Proposed Drawing Correction.

**REMARKS**

FIGURE 1

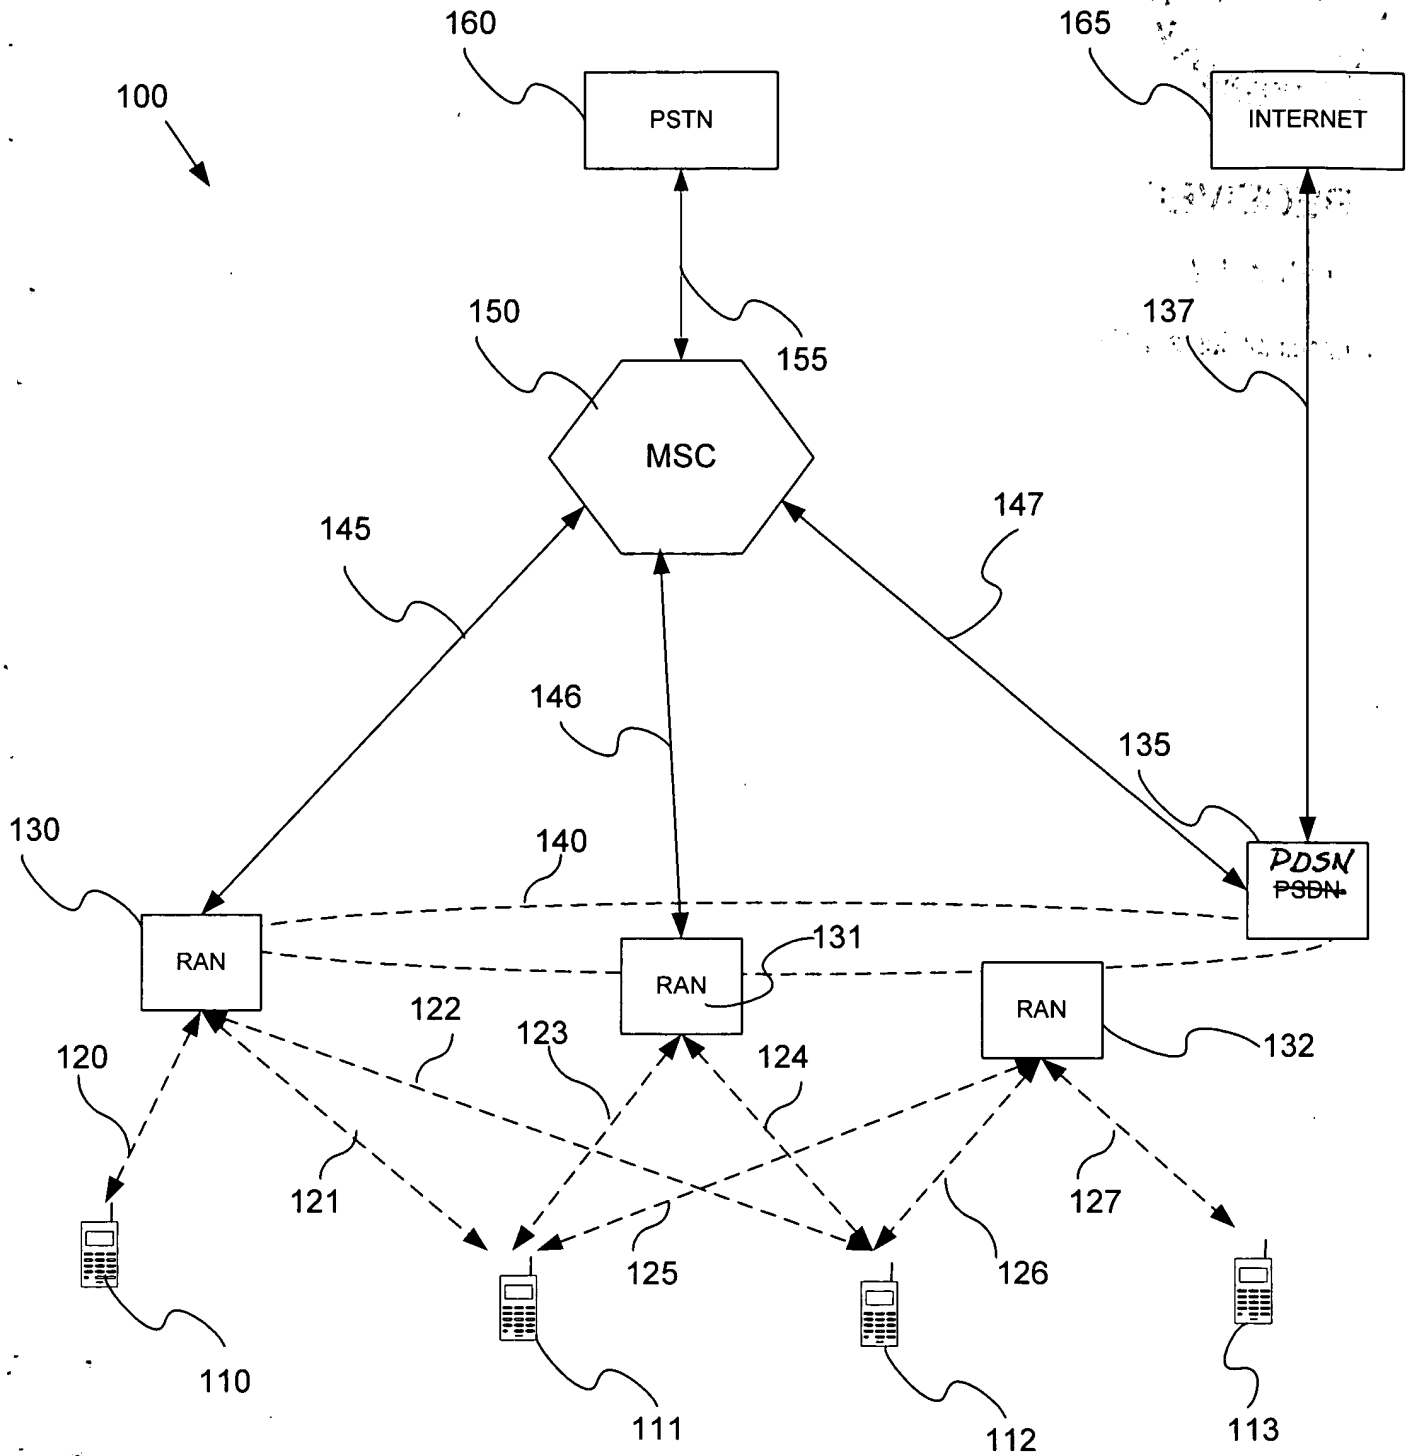
FIGURE 1 has been amended as indicated in red on a copy of FIGURE 1 as originally filed. Specifically, FIGURE 1 has been amended to correct a block identification from “PSDN” to “PDSN.” Support for this change may be found in the original specification beginning on page 11, at line 7, wherein it states: “Packet data server node PSDN 135 is a packet routing device that provides services and coordination between the subscribers in a wireless network and external networks, such as the internet 165.” No new matter has been added by this change.

FIGURE 2

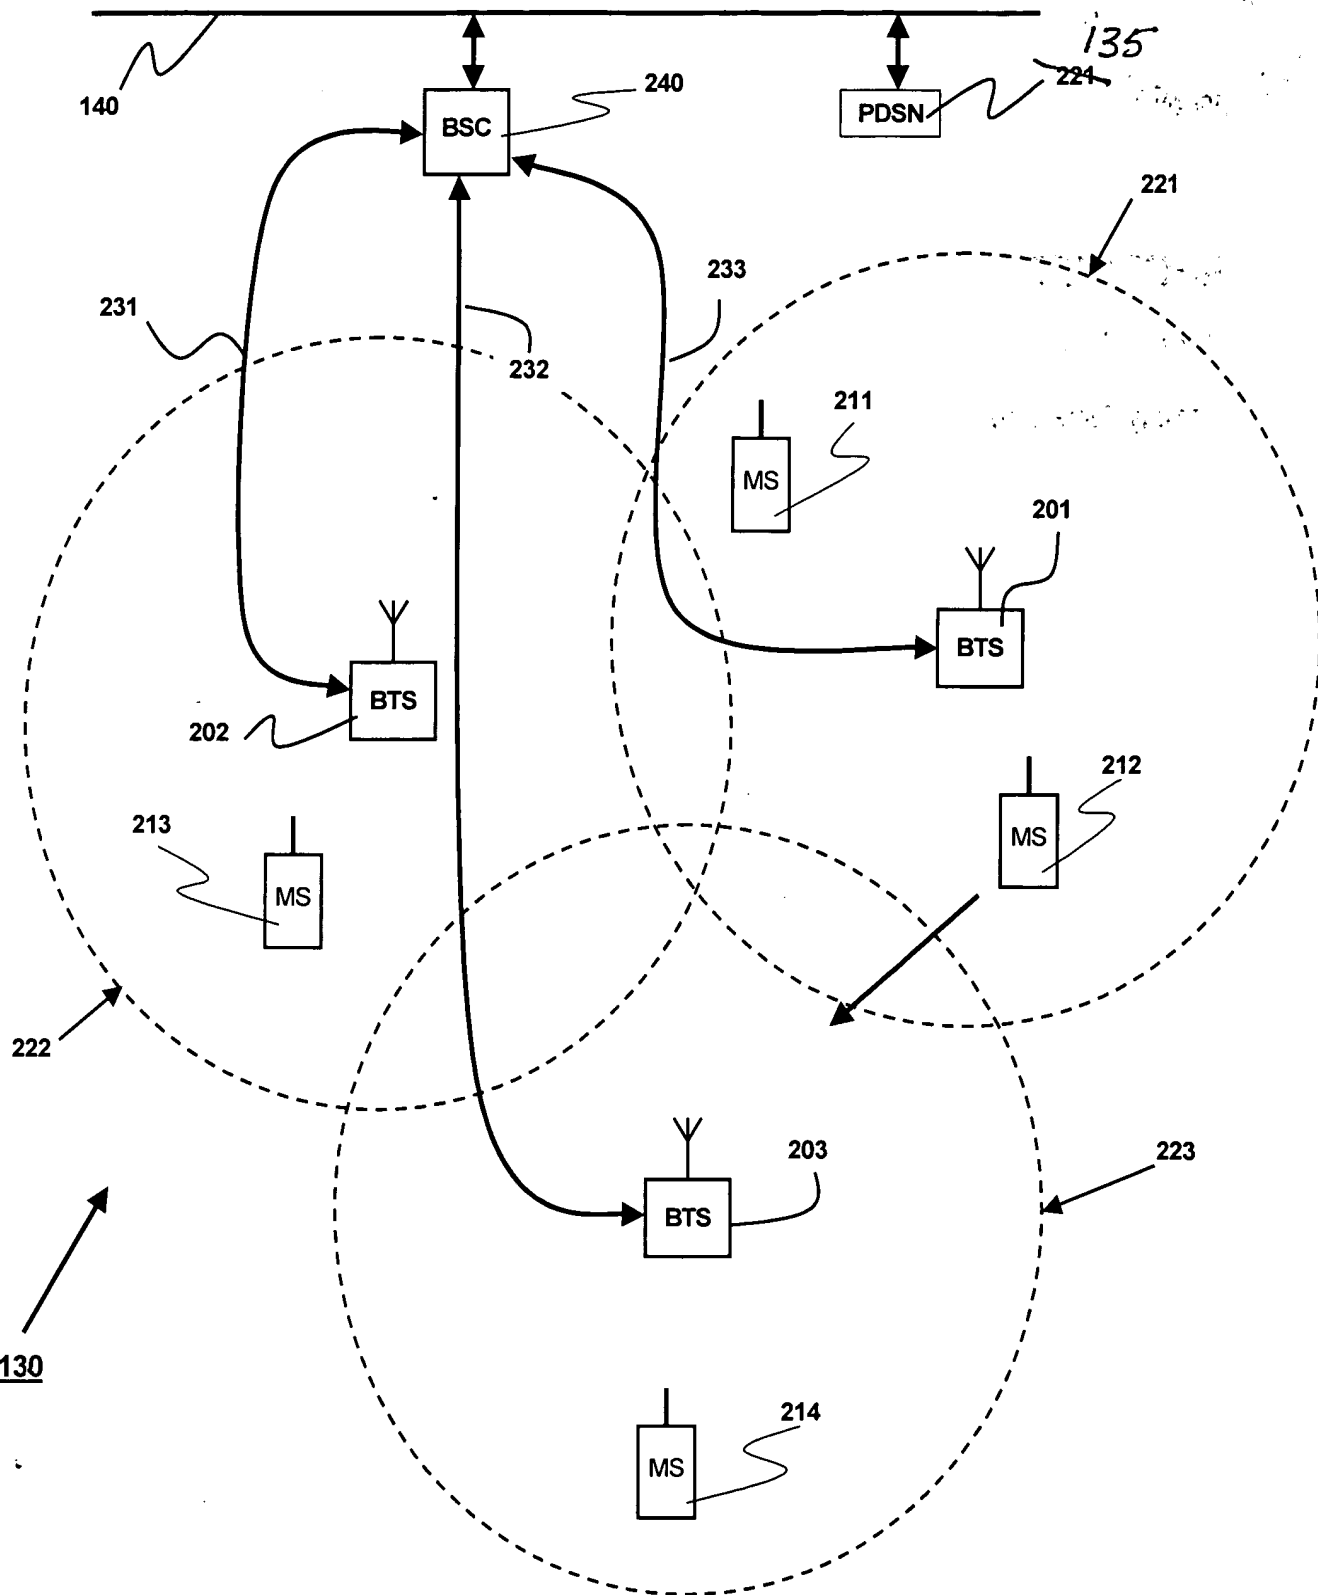
FIGURE 2 has been amended as indicated in red on a copy of FIGURE 2 as originally filed. Specifically, FIGURE 2 has been amended to replace label 221 with label 135 in the block diagram of a radio access node. Support for this change may be found in the original specification on page 11, at line 7, wherein it states: “Packet data server node PSDN 135 is a packet routing device that provides services and coordination between the subscribers in a wireless network and external networks, such as the internet 165.” No new matter has been added by this change.

FIGURE 3

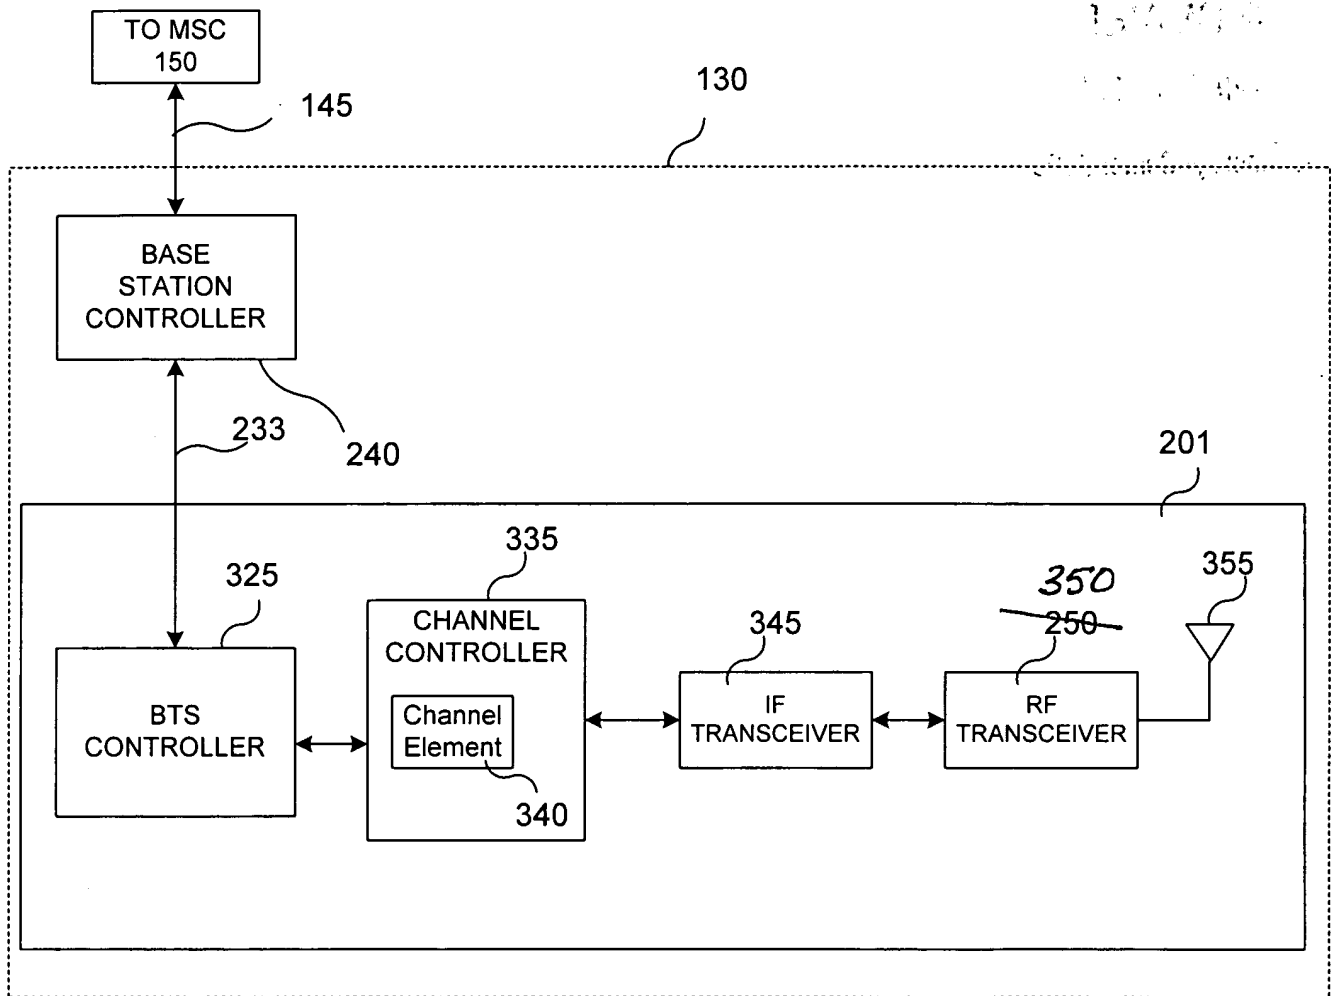
FIGURE 3 has been amended as indicated in red on a copy of FIGURE 3 as originally filed. Specifically, FIGURE 3 has been amended to replace label 250 with label 350 in the block diagram of a

radio access node in greater detail. Support for this change may be found in the original specification on page 19, at line 3, wherein it states: "BTS 201 comprises BTS controller 325, channel controller 335, which contains representative channel element 340, transceiver interface (IF) 345, transceiver unit 350 and antenna array 355." No new matter has been added by this change.
